D		1. Name of the person or organization 2. Address 3. City 4. State 5. Zip		Datum Name			
				Report Date Gepr. Worm		CORE.CIR/001.sht MS-855-C2	
Zust.		Datum		 BMW AG MÜNCHEN		Blatt 1 81	
21	22	23	24

17	0	C2-Muster angelegt	01.08.2003				W1				
18		Pull-Up fuer BWS3	29.09.2003	W1		Datum	Name	interface.cir/001.s			
					Bearb.	03/11/13 12:23:43	Q179013				
					Gepr.						
					Norm.						
								MS S65_C2		Blatt 1	
										3 Bl.	
Zust.	Aenderung	Datum	Name	BMW AG Lower: RE-223, 80788 München "				Ersetzt fur: "		Ersetzt durch:

Mit VISULA erstellt					Datum	Name	Kurzz.
11	C2-Muster erstellt	01.08.2003	Wi	Bearb.			
				Gepr.			
				Norm			
Zust.	Änderung	Datum	Name	Simul.

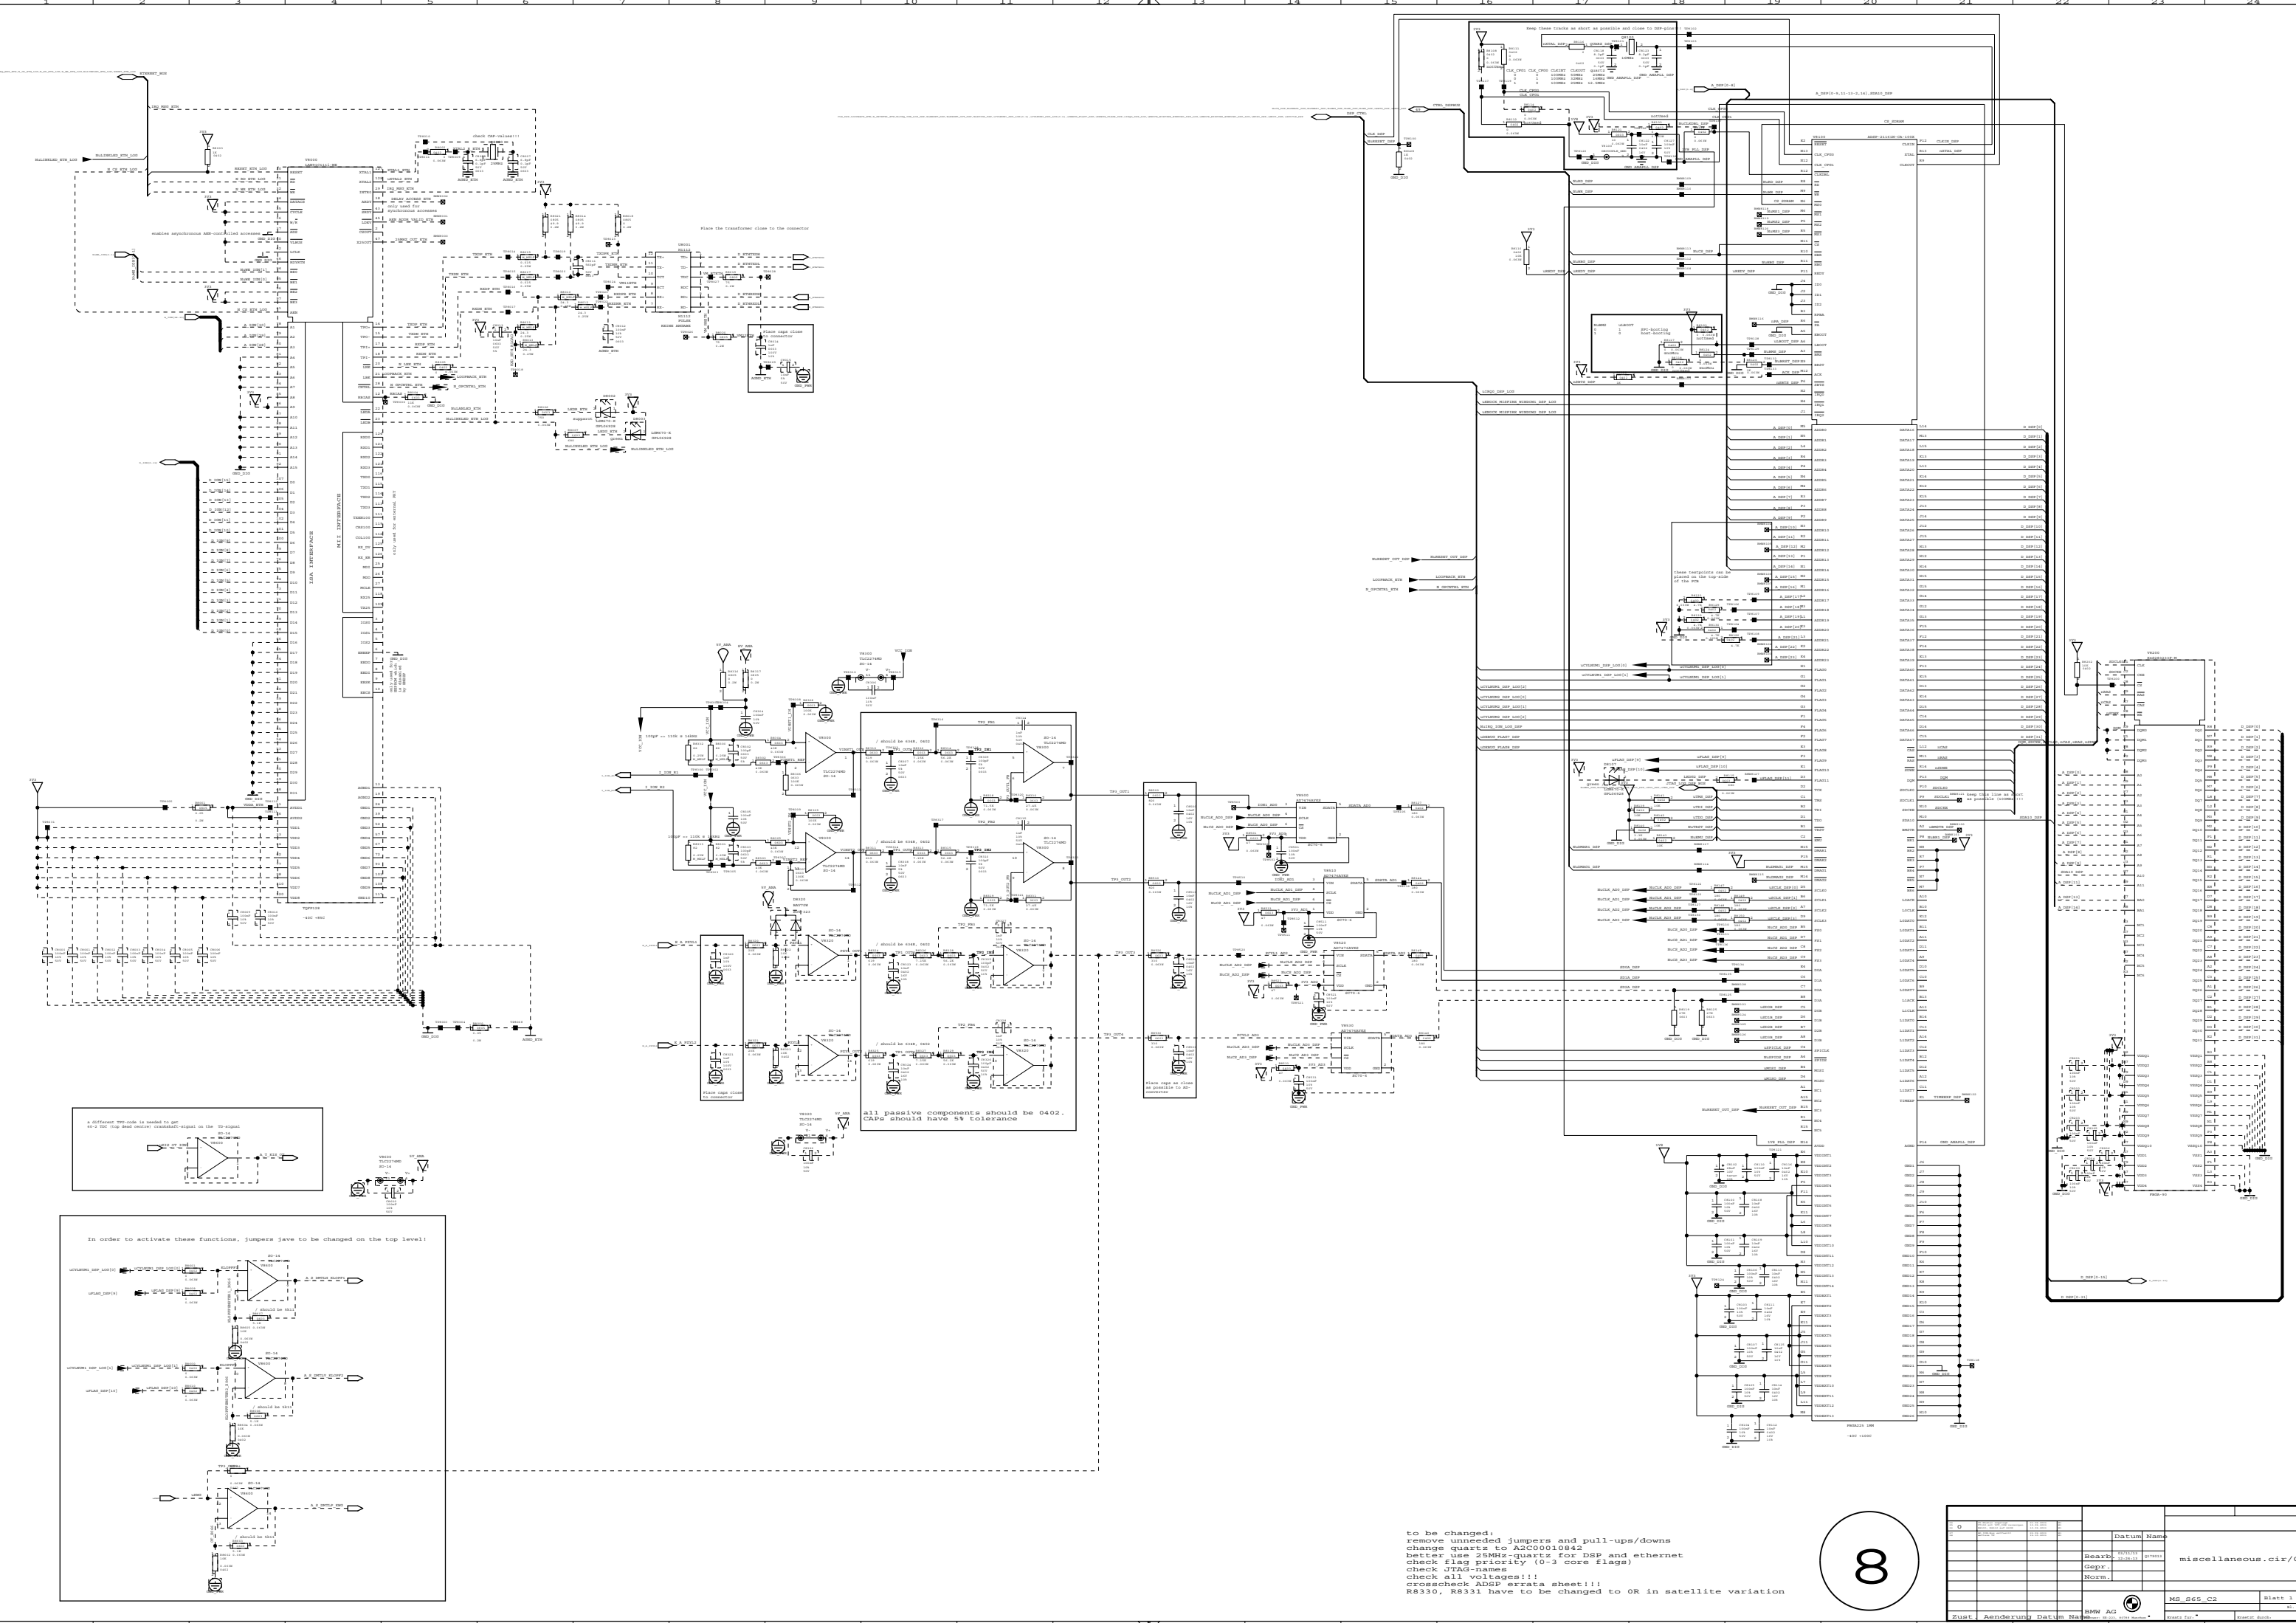
to be changed:
remove unneeded jumpers and pull-ups/downs
change quartz to A2C00010842
better use 25MHz-quartz for DSP and ethernet
check flag priority (0-3 core flags)
check JTAG-names
check all voltages!!!
crosscheck ADSP errata sheet!!!
R8330, R8331 have to be changed to 0R in satellite variation
